Staff Evaluation First Review

Application: Timothy Schmidt, Schmidt Planned Unit Development – Seeking recommendation to the City Council for a concept plan for a 4 Lot single family dwelling planned unit development located at 182 North 600 East.

Application Number: 26-010
 Preparation Date: May 6, 2026
 Applicant Name: Timothy Schmidt
 Property Owner: Timothy Gordon Schmidt
 Property Address: 182 North 600 East
 Parcel Number: 01-013-0030
 Parcel Area: 3.22 Acres

CONCEPT PLAN

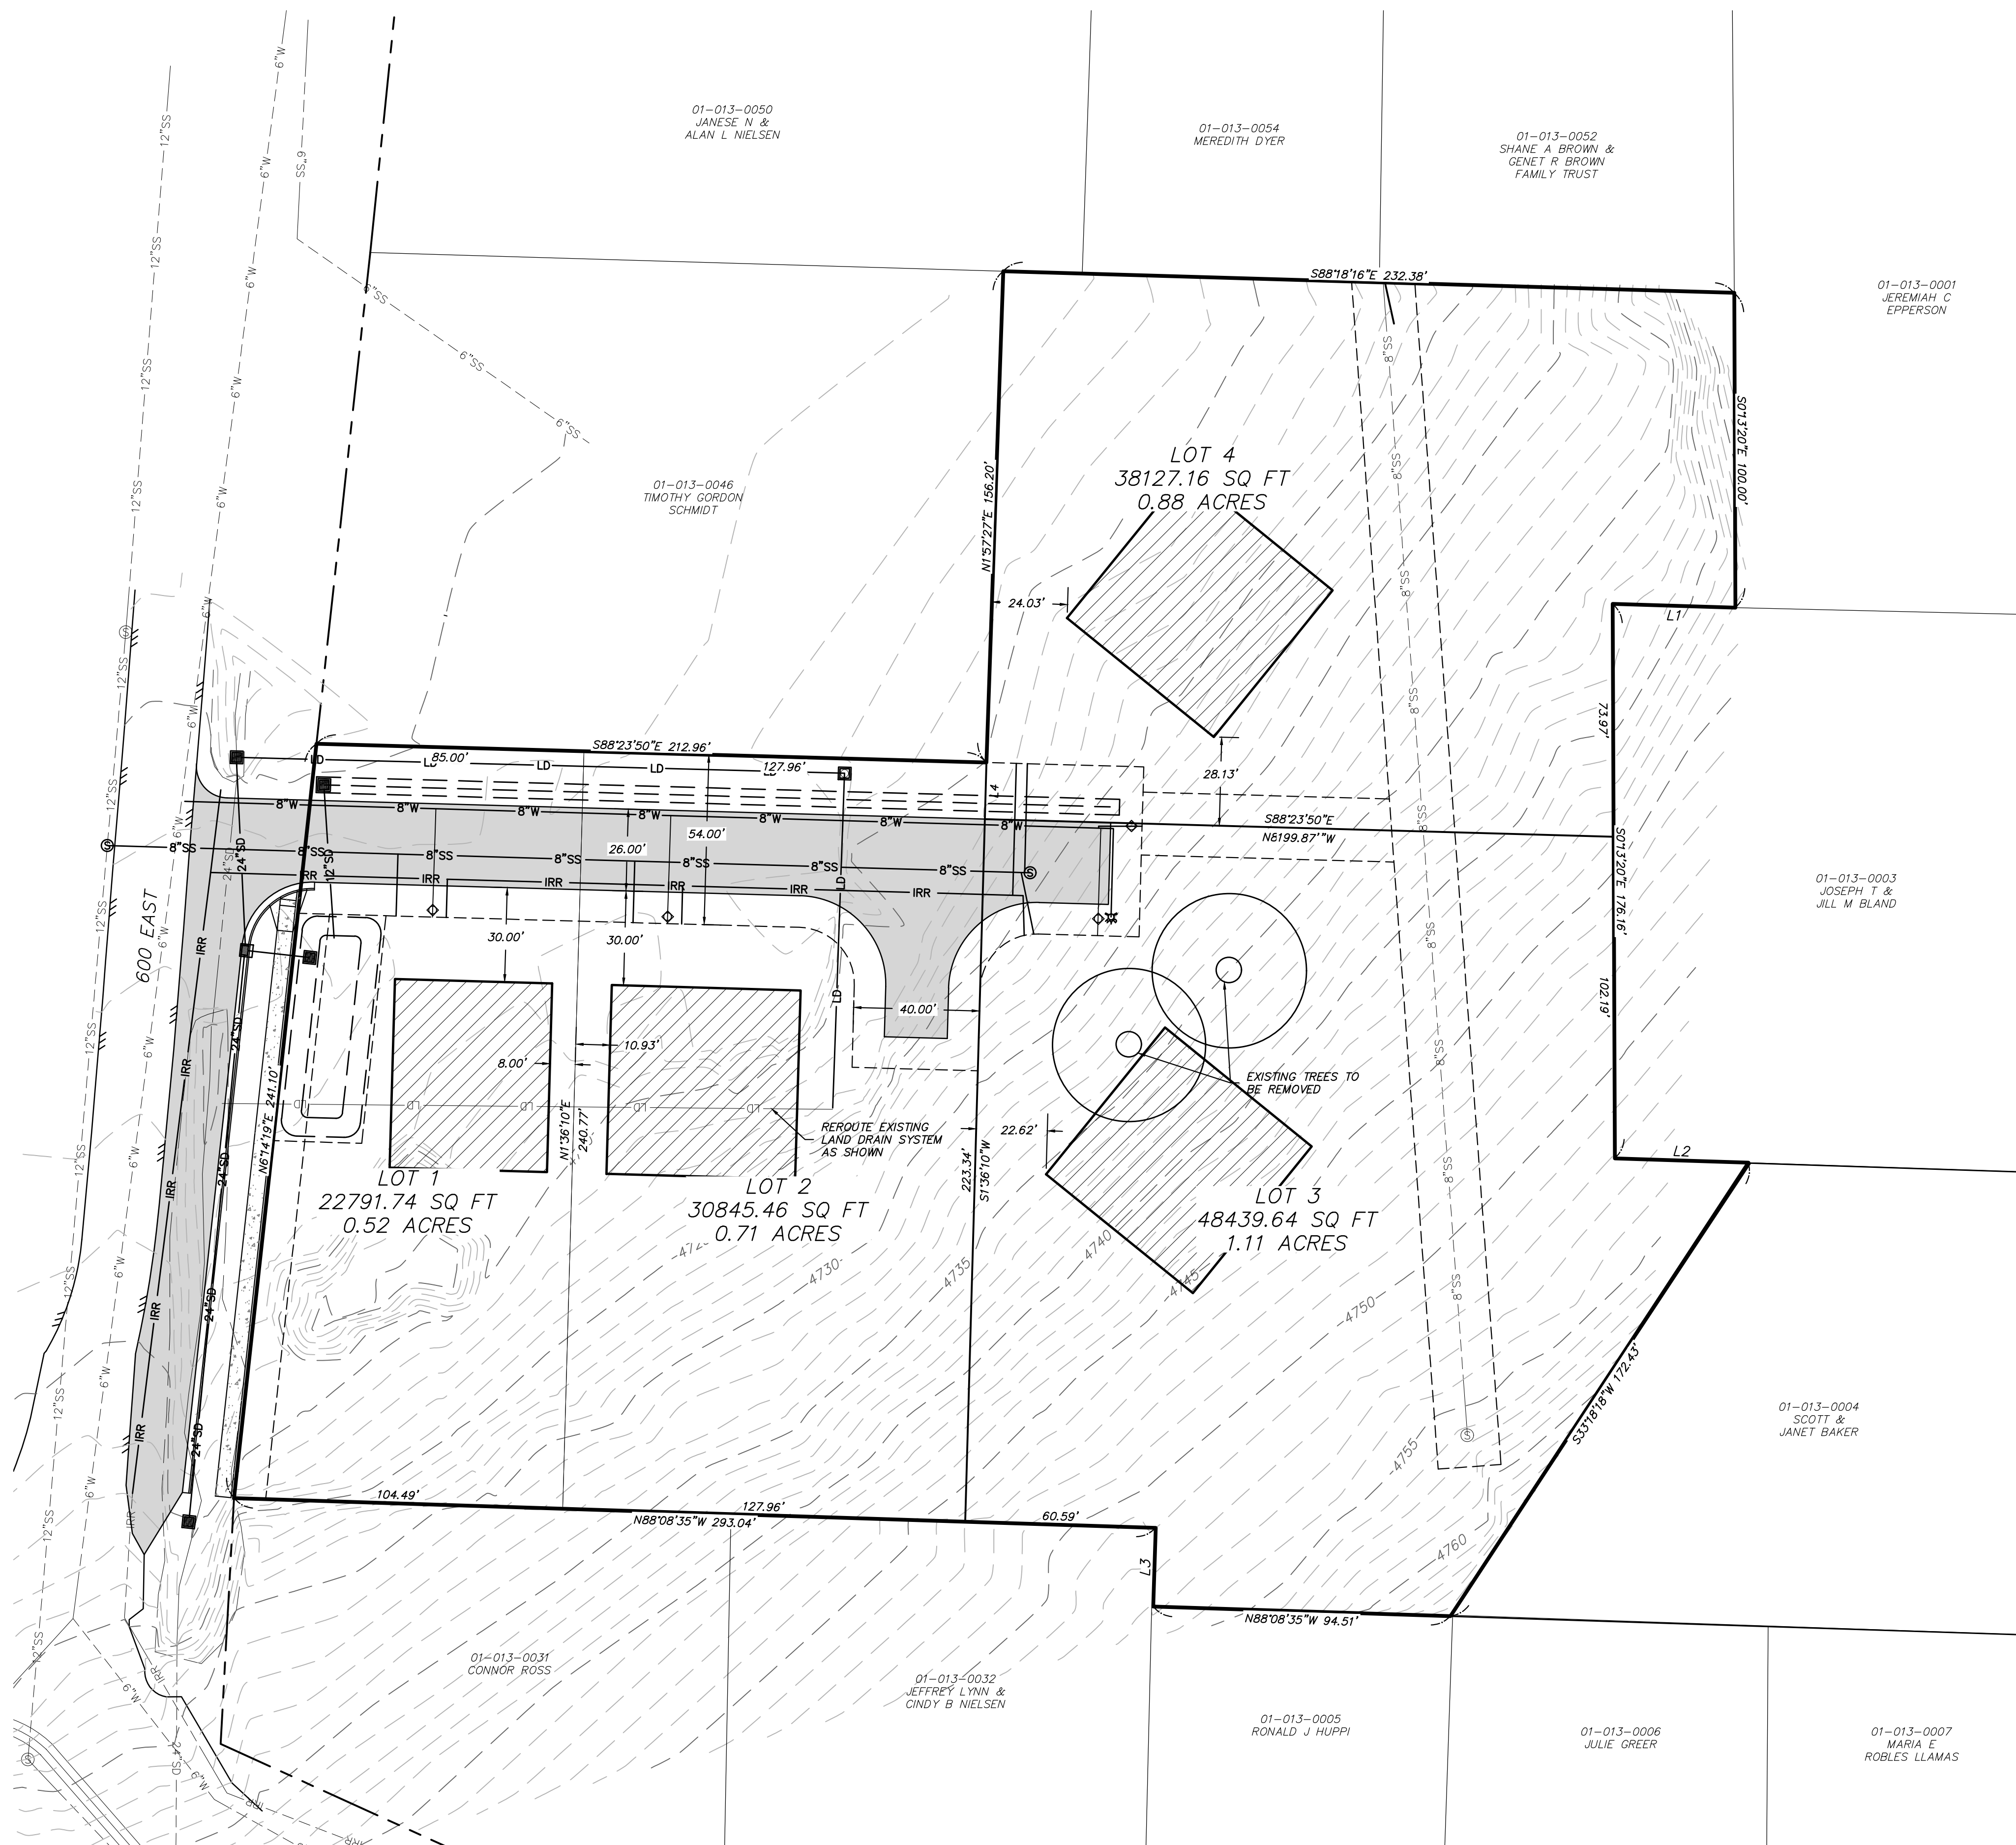
- b. Sufficient public open spaces and amenities that will provides a safe, comfortable and pleasant environment;
Staff comment: The applicant did not provide public open spaces and amenities within the PUD. There are areas of easements for the swale, shared driveway, and storm water pond.

- c. Appropriate building types in terms of density, site relationship and spacing.
Staff comment: The applicant is proposing single-story single family private dwellings with a density 1 unit per 0.80 acres; whereas the PUD deviation for consideration given to multi-family PUD developments is 10 units per acre.

- f. Good vehicular and pedestrian movement;
Staff comment: There are no pedestrian pathways proposed within the PUD and there is one vehicular shared driveway through private property parcels.

- g. Integrated parking;
Staff comment: There is no integrated parking for the PUD.
 - h. Landscaping plan showing existing and proposed, grass, shrubbery, trees and other planting and features for the entire site;
Staff comment: There are two (2) existing trees that are noted on the PUD to be removed, and the private lots do not show landscaping other than landscaping noted in Comment Items #1.e.

- i. Placement of fencing/walls and solid waste enclosures.
Staff comment: There are no fencing/wall details or solid waste enclosures identified in the PUD.

- b. The land drain proposed along the North edge of the driveway is a significant concern. The introduction of land drains to storm drain infrastructure eliminates capacity from the existing and proposed systems due to the need to convey groundwater continually. This is especially evident in the case of retention ponds. Any land drain upstream of a detention pond, such as the one proposed in this concept plan, will fill the detention volume in the pond set aside to allow for infiltration of smaller storms and maintain a constant pool of water in the bottom of the pond. The connection of land drains to storm water infrastructure is generally not prudent Engineering design and should be considered prior to acceptance.

3. Slope Concerns:
 - a. Slope through the property is significant, but the areas over 30% seem to be as a result of material stock piling and not natural slope. The areas that are naturally over 20% appear to be limited in nature and would likely not pose significant challenges in the construction of homes on the site. In general, large retaining walls would likely be required to construct homes on lots 3 and 4.

4. Other Consideration:
 - a. The proposed design creates three lots that do not front a public right of way but are only accessible through an access easement provided by the developer.

- b. The proposed infrastructure does not provide sidewalk, curb and gutter, or an appropriate turnaround radius.
 - c. The location of the driveway on Lot 4 is unknown and would conflict with the proposed swale on the north side of the roadway.

1. What is the grade of the road? Not to exceed 10 percent in grade.

1. Water service for lot 4 should be run to the other side of swale to the north. Services should not run parallel with the main line.
2. Fire Hydrant will need its own valve and 6" fire line. The water department prefers all fire lines to be short crossing street sections.

3. Both water mains will require a tie-in feed valve in public ROW. Both water mains will need a 2" blow off at dead ends in utility easement. All hookups on both water mains need to be properly spaced to manufacture specs.

4. Both irrigation and culinary meter bases should not be in driveways. Are there any house plans showing future build models to determine where locations are?

5. Irrigation will be tied to the end drain of existing irrigation. This will need to be looked at for depth and sizing by the city. If extended, a new drain will need to be installed on the future drain box on the north end of access in public ROW.

6. All water and sewer laterals will need 18" vertical separation. All water and sewer need 10' horizontal separation.

7. Prefer to see some kind of ribbon curb on the swale edge to keep up the integrity of the roadway shoulder.
8. Any interior sidewalks?
9. Cross access agreements for homeowners and public utilities? Utility ROW should be drivable access with proper width.
10. Snow storage in swale? Snow storage should not be in utility access ROW or brought out to public ROW.
11. Curb and gutter radius on both sides of access entering public ROW. Sidewalks need ADA.
